Contract #: 04-0120F4
 Cty: SF/ALA Rte: 80 PM: 13.2/13.9
 File #: 69.25B

QUALITY ASSURANCE -- NON-CONFORMANCE REPORT

Report No: NCR-000595

Reference Description: Inadequate preheat on South Tower, Lift 2, Skin C Temporary Lifting Eye

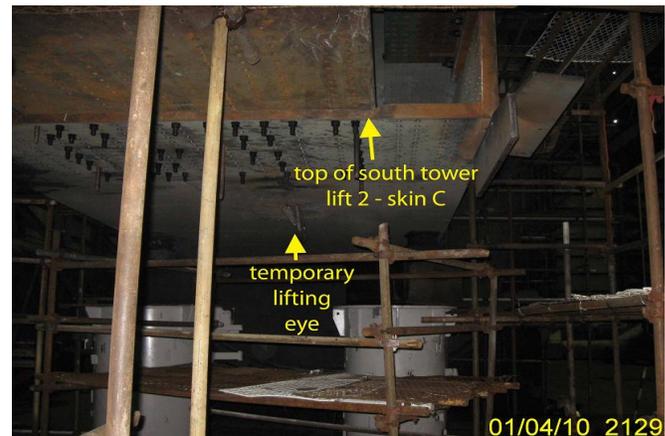
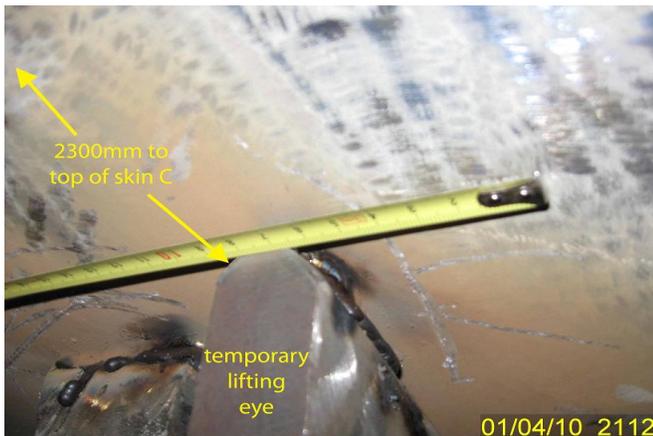
During in-process Visual Testing (VT) of South Tower, Lift 2, Skin C, QA observed ZPMC personnel performing Shielded Metal Arc Welding (SMAW) of partial joint penetration weld attaching a temporary lifting eye plate without sufficient base material preheat. A 110 degree Celsius Tempilstik temperature indicator mark applied to the adjacent base material within approximately 30mm from the point of welding did not melt.

Welding Procedure Specification WPS-B-T-2314-TC-P5, designated as the applicable WPS by ZPMC QC, requires a minimum preheat temperature of 110° Celsius.

AWS D1.5-2002, Section 4.2.7 requires the base metal material to be at or above the specified minimum temperature for a distance not less than 75mm in all directions from the point of welding.

Reference Resolution: In the future ZPMC will have a welding repair report for repairs of temporary attachments so that the parameters of the weld are clear to the production and QC personnel.

ZPMC is providing NDT documentation of the temporary weld to show that it is acceptable. In this specific case, ZPMC has discussed the importance of applying the same preheating requirements to temporary attachments as permanent welds with the production foreman. The production foreman has acknowledged that the area should have been preheated prior to welding. ABFJV has discussed this with ZPMC and in the future ZPMC will have a welding repair report for repairs of temporary attachments so that the parameters of the weld are clear to the production and QC personnel. Based on these actions and the NDT documentation, ZPMC requests closure of the NCR.

The proposed resolution is acceptable. The Department concurs that Non-conformance ZPMC-0568 is closed.

Reference Description: Inadequate preheat on South Tower, Lift 2, Skin C Temporary Lifting Eye

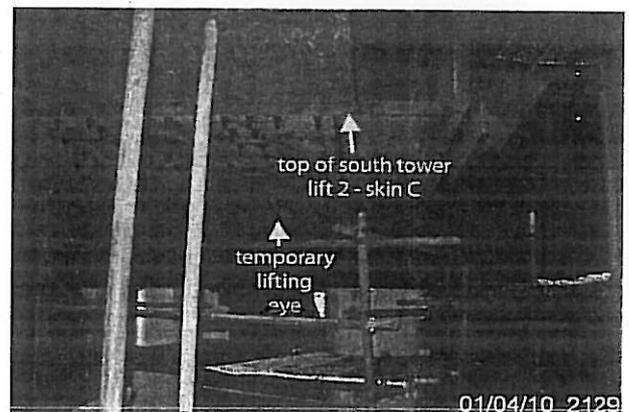
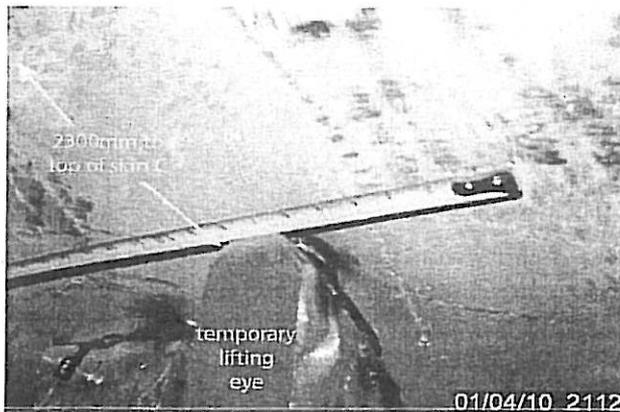
During in-process Visual Testing (VT) of South Tower, Lift 2, Skin C, QA observed ZPMC personnel performing Shielded Metal Arc Welding (SMAW) of partial joint penetration weld attaching a temporary lifting eye plate without sufficient base material preheat. A 110 degree Celsius Tempilstik temperature indicator mark applied to the adjacent base material within approximately 30mm from the point of welding did not melt.

Welding Procedure Specification WPS-B-T-2314-TC-P5, designated as the applicable WPS by ZPMC QC, requires a minimum preheat temperature of 110° Celsius.

AWS D1.5-2002, Section 4.2.7 requires the base metal material to be at or above the specified minimum temperature for a distance not less than 75mm in all directions from the point of welding.

Verify welds are acceptable, incorporate temporary welds into the scope of WRR documentation so that welding parameters are clear to production and QC staff.

Documentation for MT verification of the temporary weld was provided (T787-MT-7883). ZPMC will submit WRRs for future repairs of temporary welds.
